UNITED STATES PATENT AND TRADEMARK OFFICE
CERTIFICATE OF CORRECTION

PATENT NO. : 7,046,434 B1
APPLICATION NO. : 10/020527
DATED : May 16, 2006
INVENTOR(S) : DiJaili et al.

Figure 2

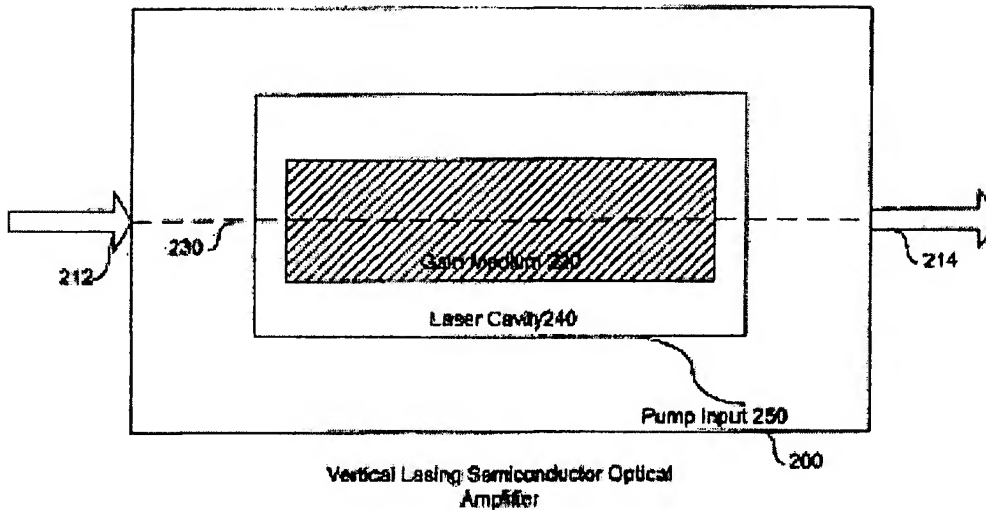
Sheet 2, change "Figure 2" to the figure depicted herein below, wherein the reference "201" has been removed.

Figure 4C

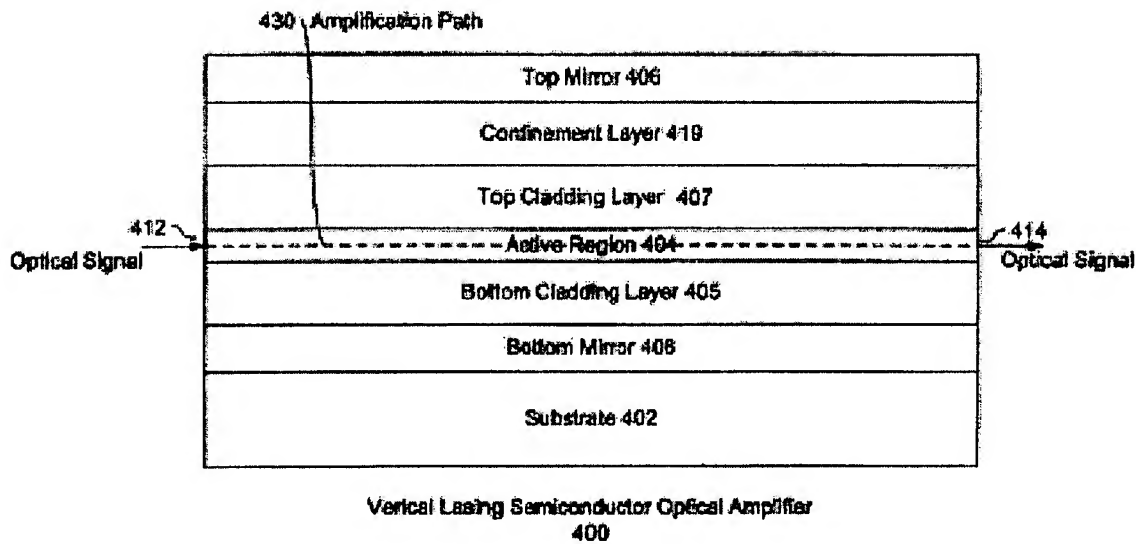
Sheet 6, change "Figure 4C" to the figure depicted herein below, wherein the Top Cladding Layer has been labeled --407--

Figure 7A

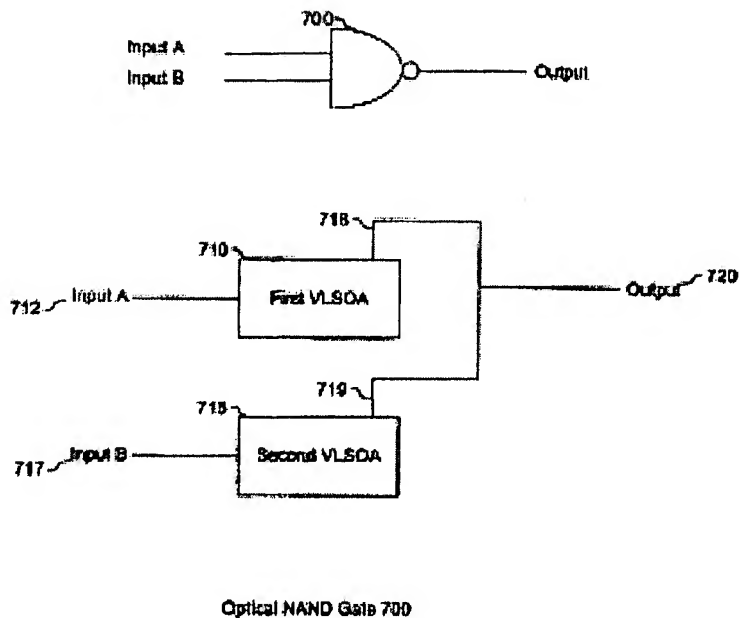
Sheet 11, change "Figure 7A" to the figure depicted herein below, wherein the NAND gate has been labeled --700--

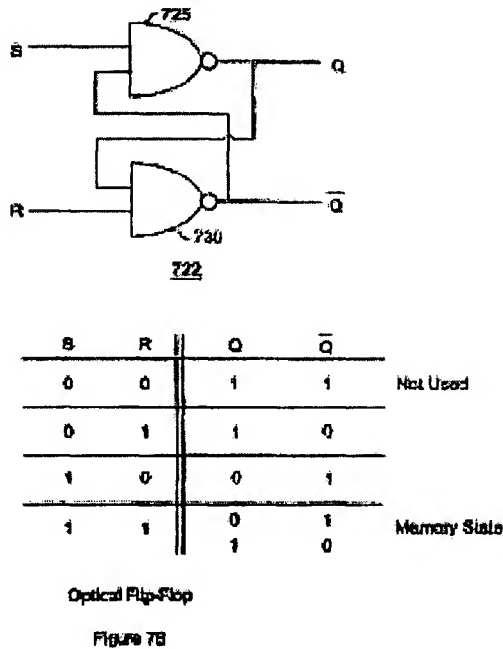
Sheet 12, change “Figure 7B” to the figure depicted herein below, wherein the 2nd and 3rd row of the outputs have been change to --1-- and --0--, and --0-- and --1--, respectively.

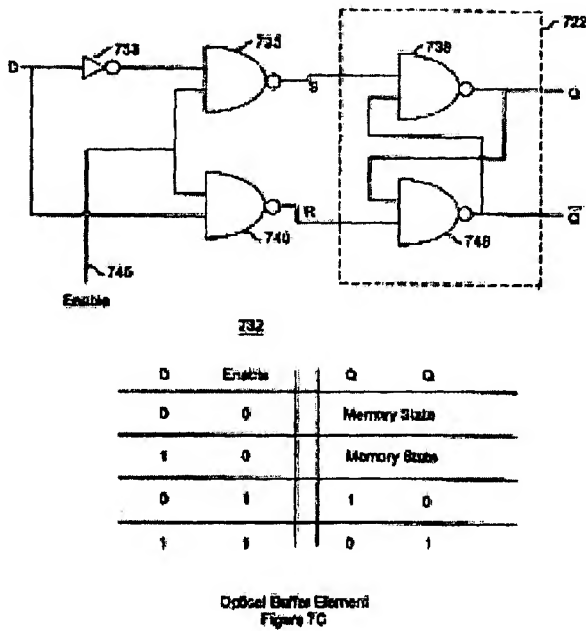
Sheet 13, change “Figure 7C” to the figure depicted herein below, wherein the 3rd and 4th row of the outputs have been change to --1-- and --0--, and --0-- and --1--, respectively.
